DOCUMENT CHANGE REQUEST

DCR number 335 Changes required for: General

Title: Transistors High Power PNP, based on type BUX78

Number: 5204/006

Maximum Safe Operating Area Graph

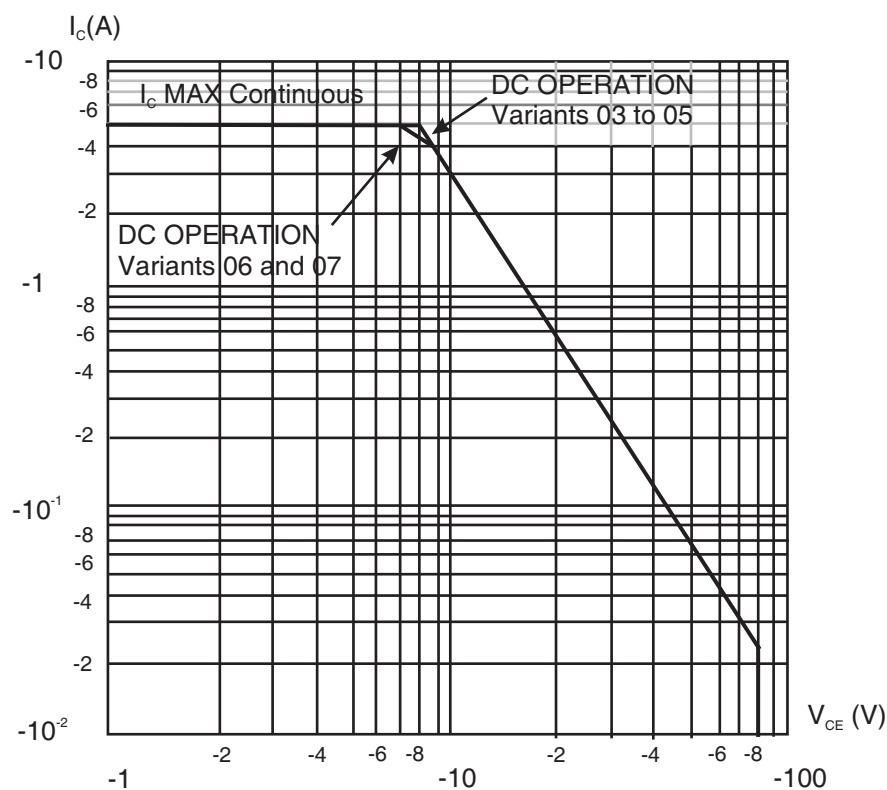
6. Figure 1(b) Forward Bias Safe Operating Area (Continuous DC) amended and moved to be a note in the Maximum Ratings table.
7. Para. 4.3.2 Weight requirements moved to Component Type Variants table.

4. Safe Operating Area applies as follows:

1.7.1 Metal Flange Mount Package (TO-66) - 2 lead

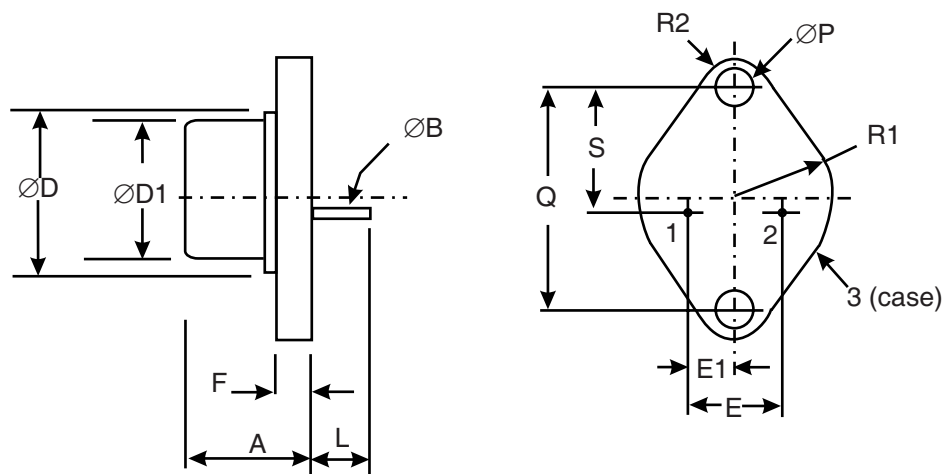
8. Figure 2 re-named "Physical Dimensions and Terminal Identification"; Figure 2(a) amended to reflect the TO-66 package currently supplied; Figure 2(b) amended to reflect the TO-257 package currently supplied. Consolidated notes added.

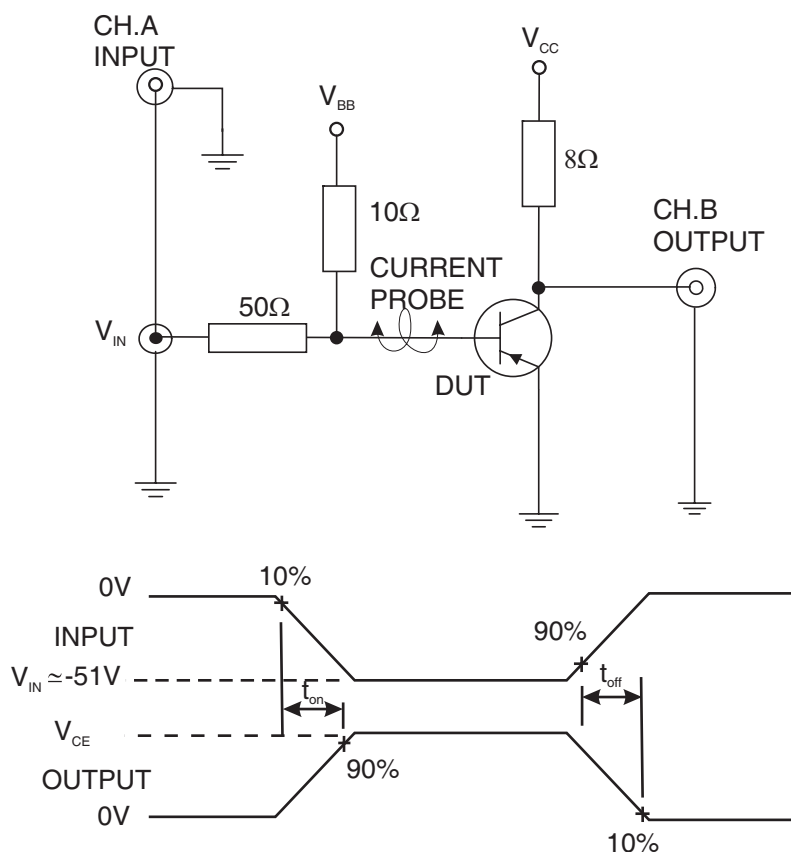
18. Table 2 and Figure 4: The Switching Times characteristics have been amended to reflect the new format.
19. Table 3, Characteristic "D.C. Forward Current Transfer Ratio 4" has been changed to "Forward-Current Transfer Ratio 4".
